FARR WEST CITY COUNCIL AGENDA

RE: **MONTANO SUBDIVISION & SITE PLAN (Willard Bay Ph 2 Subdivision 1st Amendment)
Final Improvement Drawings**

PLAN REVIEW

OVERALL SITE & UTILITY PLAN FOR
MONTANO
3770 & 3762 N. HIGLEY ROAD
FARR WEST, UTAH 84404
A Part of the Southeast Quarter of Section 2
Township 10 North, Range 2 West, S.L.B.&M.

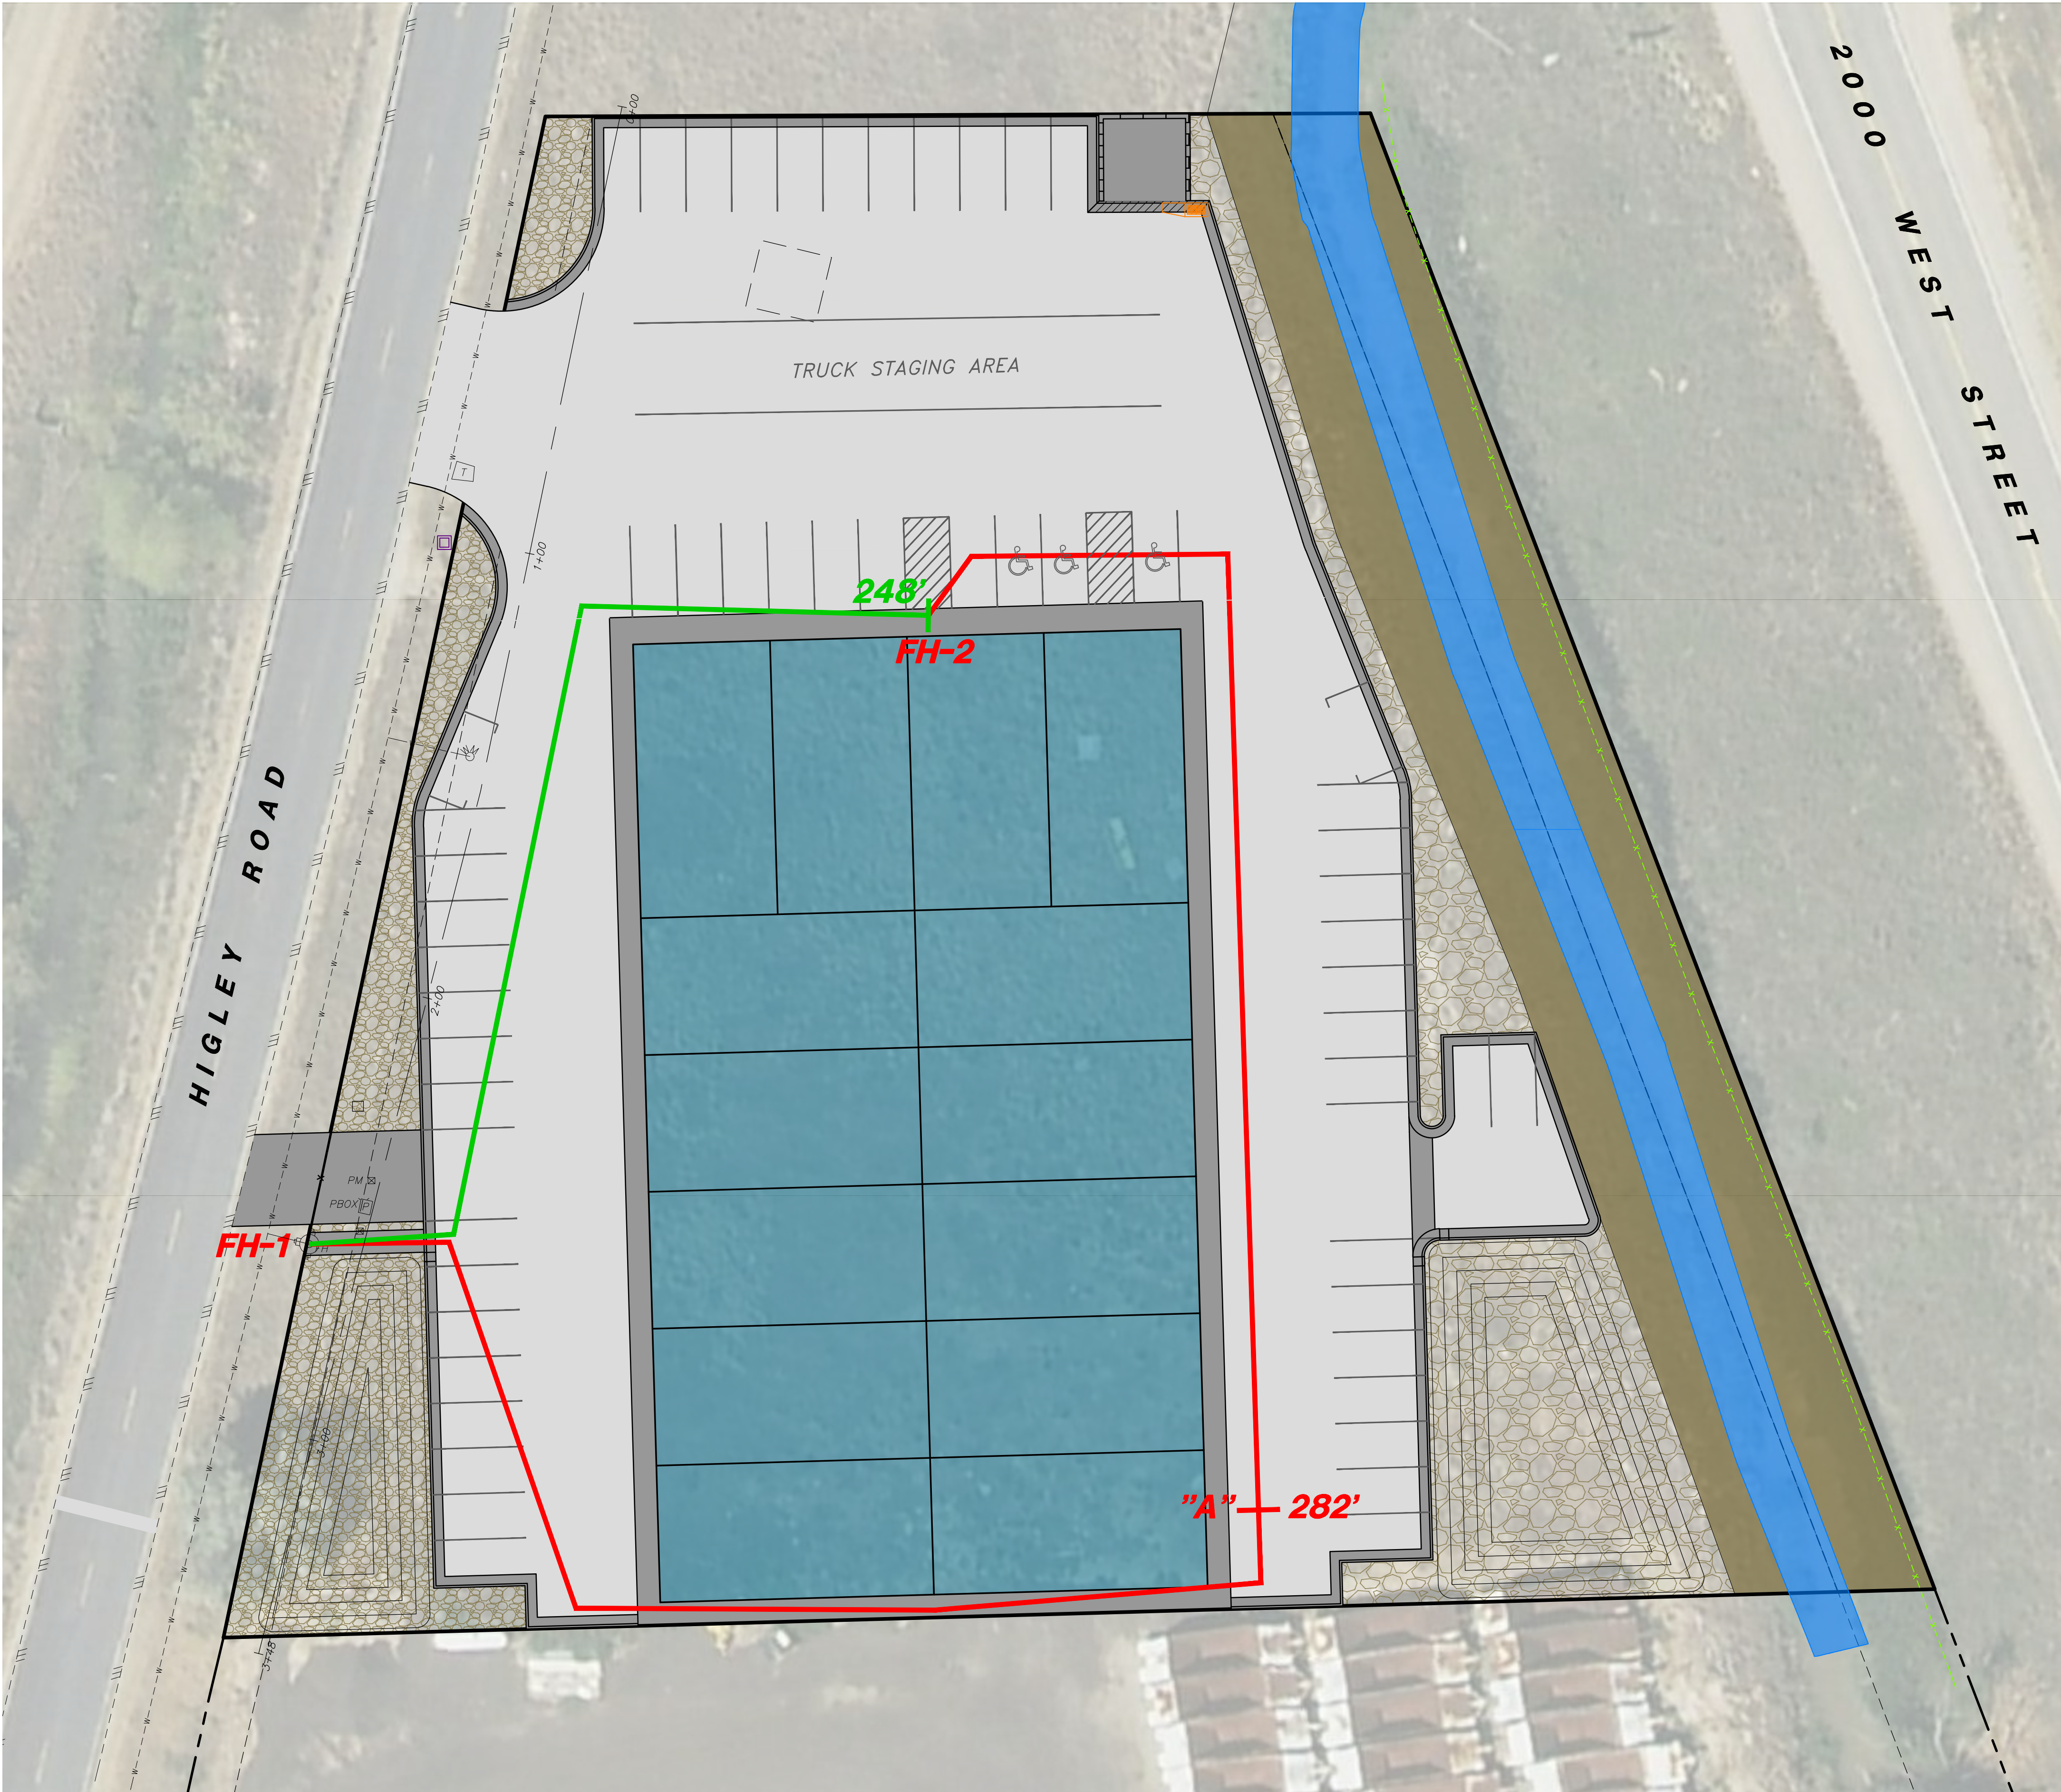
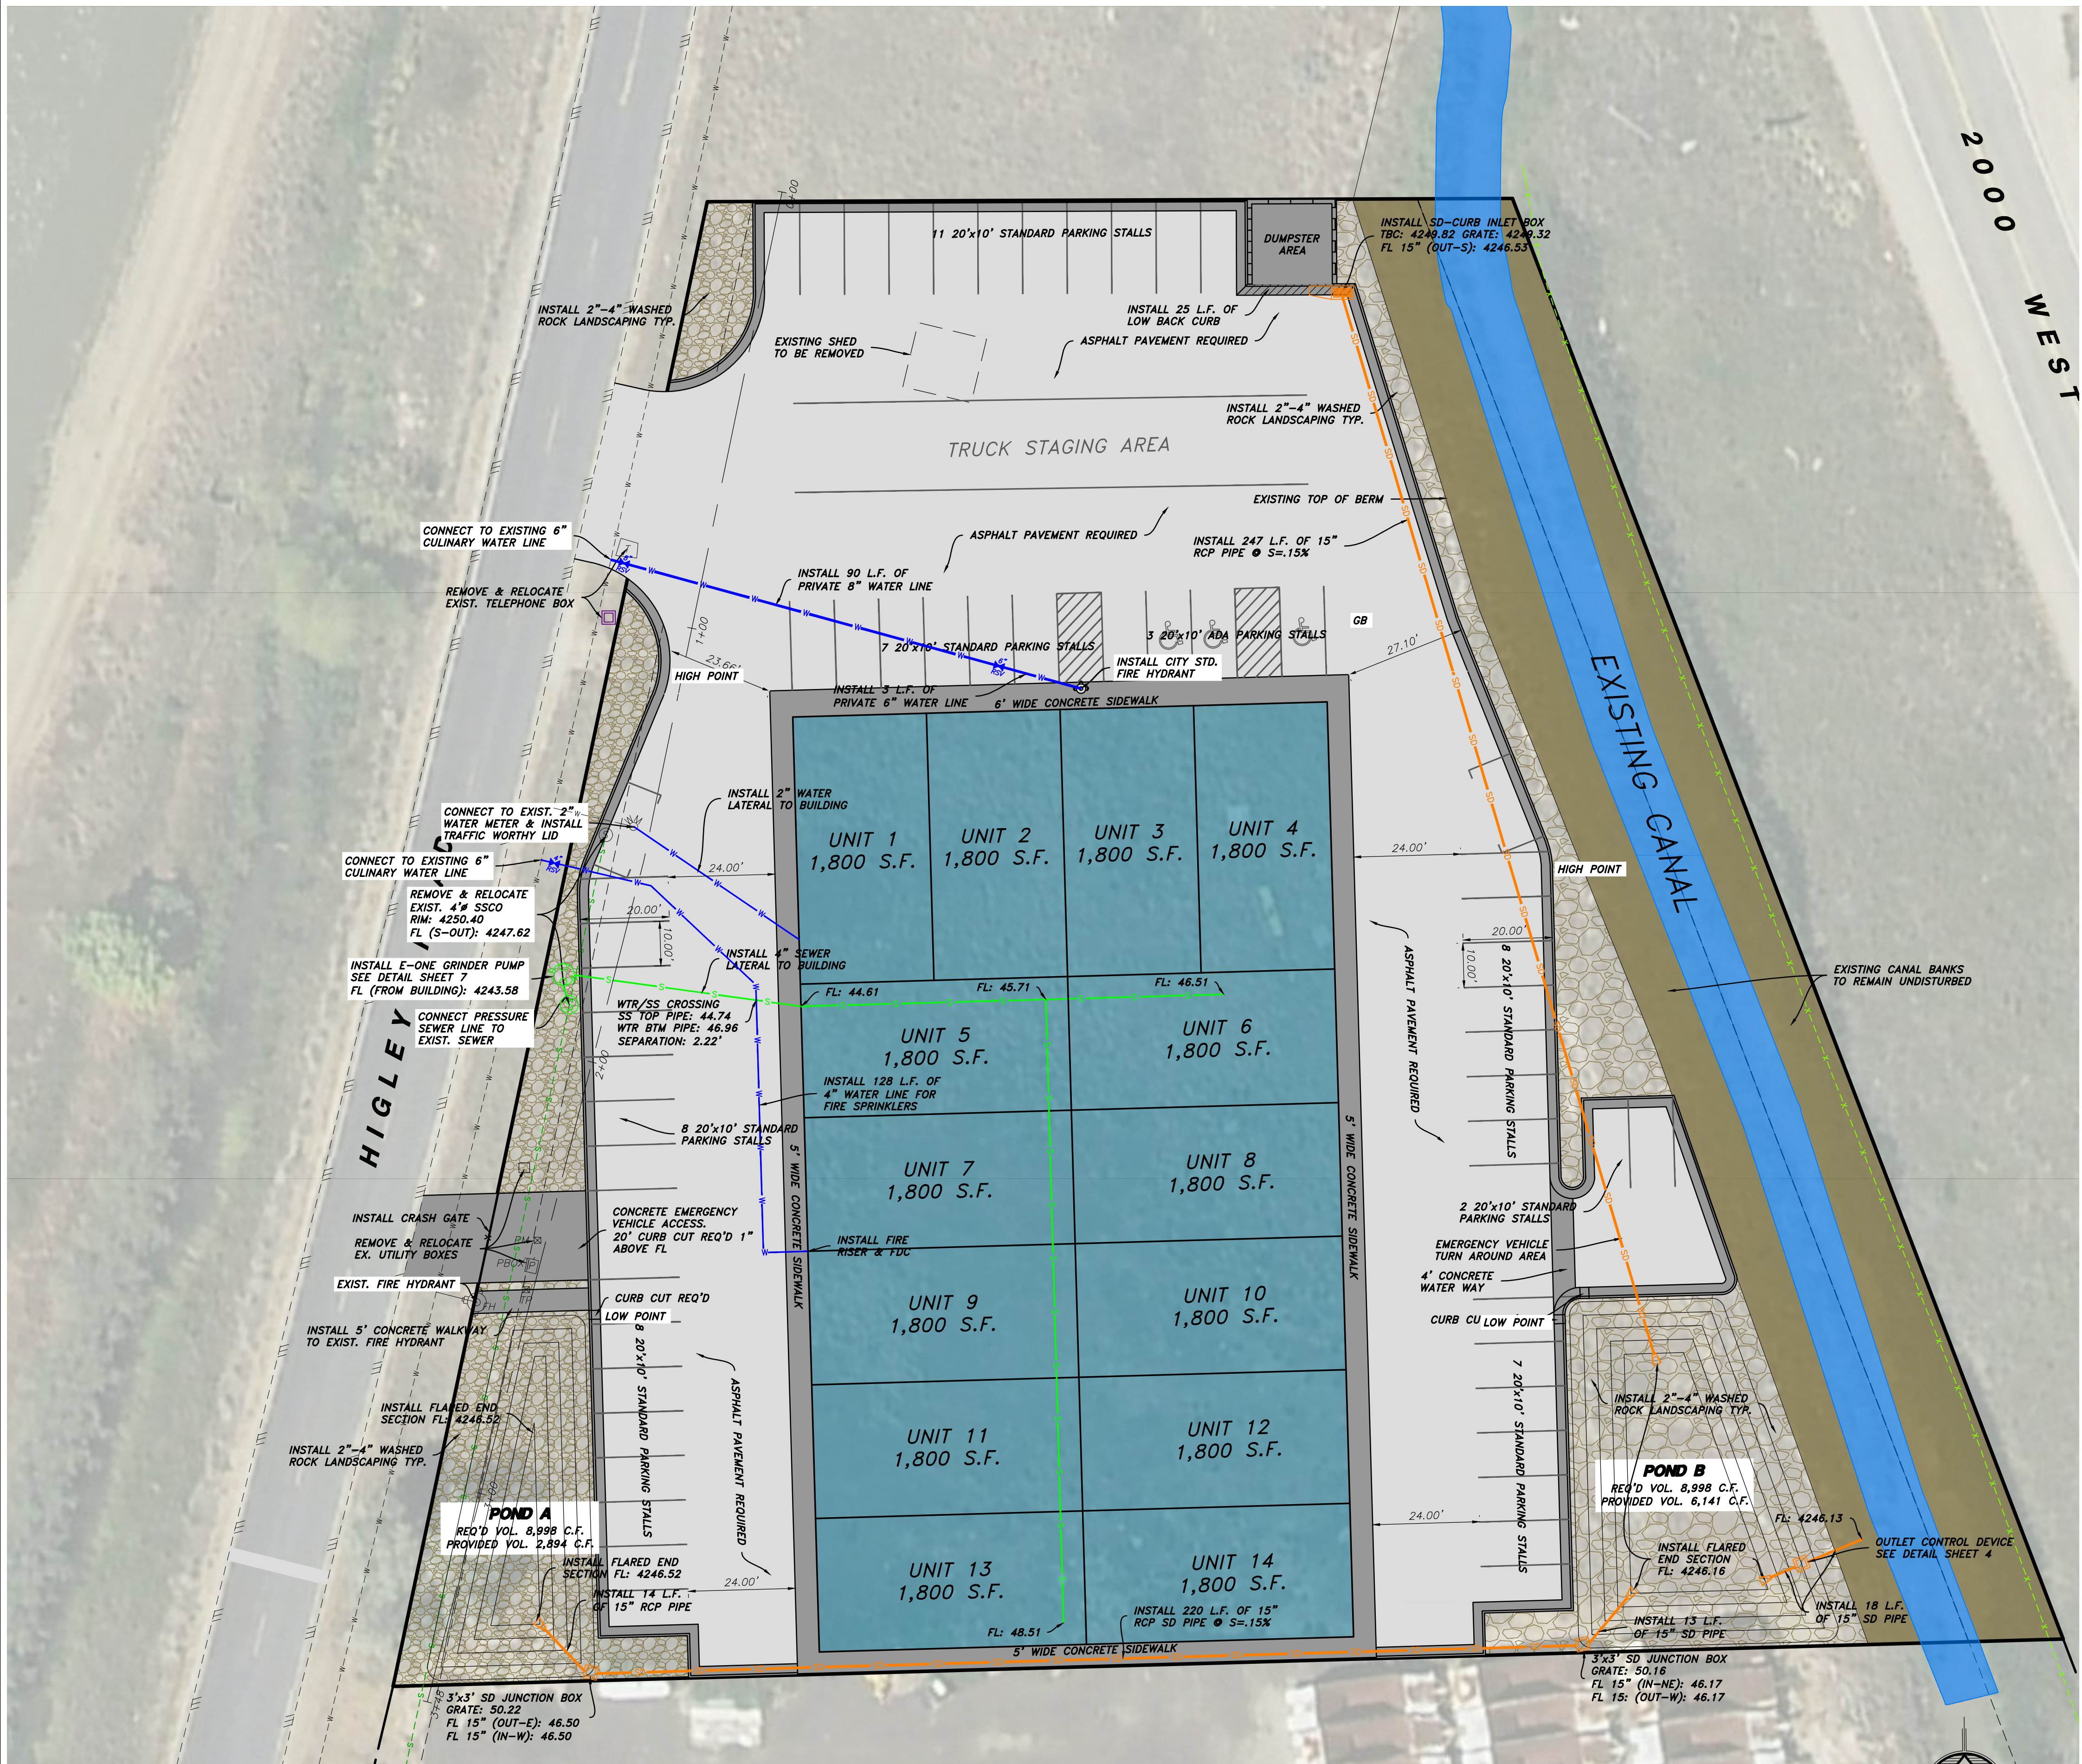
Our office has completed a review of the plat amendment and site plan for the proposed Montano site located at 3762 N Higley Rd. They are proposing to combine two lots into one and construct a new commercial building (tradesman shops) in this existing C-2 zone. We have worked with their engineer on multiple reviews and they have addressed all comments and received necessary agency approvals. The plans generally conform with City Standards, and we recommend final approval of the plat amendment and site plan at this time. The following are items that will need to be taken care of prior to beginning construction:

1. Prepare a Storm Water Pollution Prevention Plan (SWPPP) and file a Notice of Intent (NOI) with the State prior to beginning any construction.
2. Enter into a long-term storm water maintenance agreement with the City to insure that the storm water facilities will be adequately maintained and to give the City the right to inspect the facilities annually. Coordinate with the City's Storm Water Manager.
3. A pre-construction conference with the Developer and their Contractor should be held with the City and utility providers prior to beginning any construction.
